# UNITED STATES PATENT AND TRADEMARK OFFICE

APPLICATION NO.	FILING DATE	FIRST NAMED INVENTOR	ATTORNEY DOCKET NO.	CONFIRMATION NO.
09/676,805	09/29/2000	Joseph R. Stonoha	632.0001USU	2958

# Office Action Summary

FIG. 16

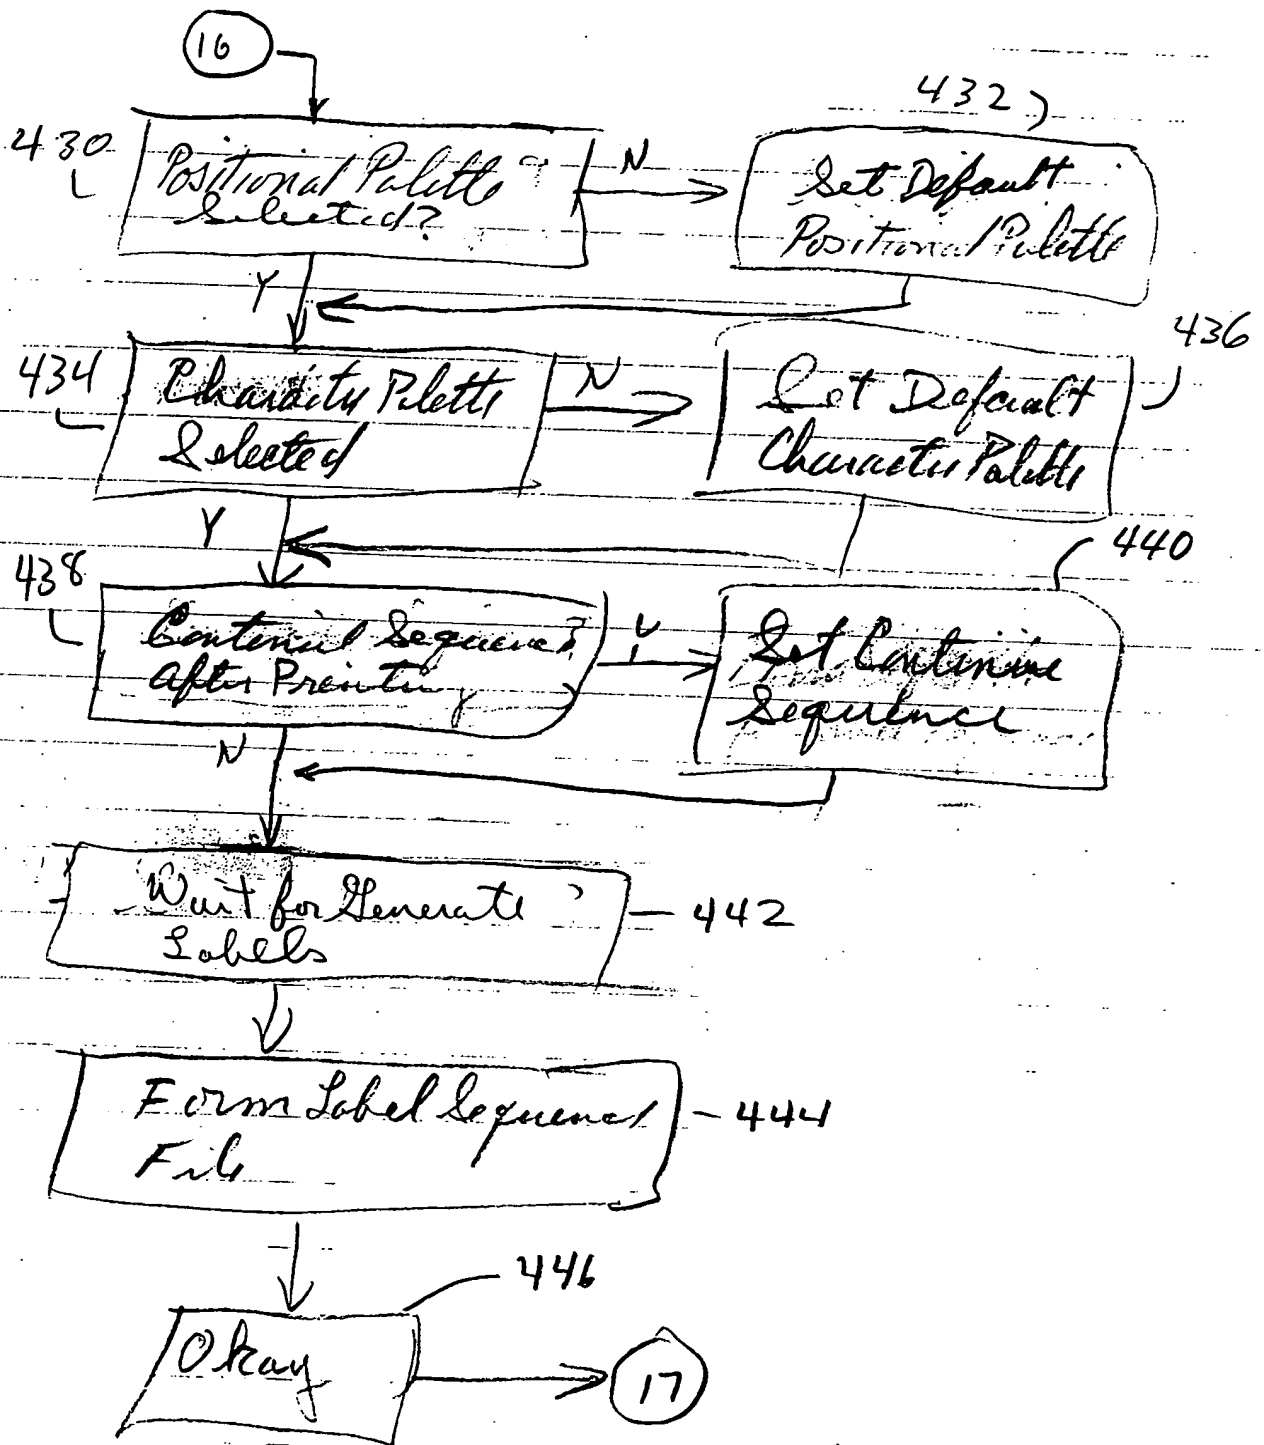
- (2) when comparing fig. 16 to the disclosure in the paragraph at page 16, lines 3-17, (as amended October 16, 2003), "Referring to FIG. 16, ... that is continued in FIG. 17.", it can be seen that fig. 16 does not correspond to it description in regard to steps 430, 432, 434, 436, 438 & 440, since it appears that the depicted flow lines do not correspond to the described operation in regard to these steps, (see below).

(a) 438 of fig. 16 if the inquiry is "NO" as described in the paragraph at page 16, lines 3-17, "Referring to FIG. 16, ... that is continued in FIG. 17.", (see below).

B) a careful comparison of features of the invention as contained in fig. 16 as amended on 16 October 2003, (see attached copy), to the context of the description contained in the paragraph located at page 16, lines 3-17, "Referring to FIG. 16, ... that is continued in FIG. 17.", (as amended 19 March 2004), clearly indicates that applicant has used incorrect reference numbers in this paragraph when making reference to the corresponding features of fig. 16. Below is a proposed amended paragraph based on the attached fig. 16 that makes the disclosure and fig. 16 consistent:

--Referring to FIG. 16, point 16 continues FIG. 16, to step 430 that determines if a positional palette has been selected and, if not, step 432 sets a default positional palette. Step 434 responds to a Yes determination of step 430 or to a completion of step 432 to determine [Step 434 determines] if a character

palette has been selected and, if not, step 436 sets a default character palette. [If yes, step 434 records the selected character palette.] Step 438 responds to a yes determination of step [430] 434 or to a completion of step [432] 436 to determine if the ordered sequence is to be continued after printing. If so, step 440 records or sets continue the sequence. Step 442 responds to a [Yes] No determination of step 438 or a completion of step 440 [to waits] by waiting for actuation of generate labels button 188 (FIG. 8). When generate labels button 188 has been actuated, step 444 forms a labels sequence file. Step 446 waits for actuation of OK button 190 (FIG. 8). When OK button 190 has been actuated, control passes to a point 17 that is continued in FIG. 17.--.
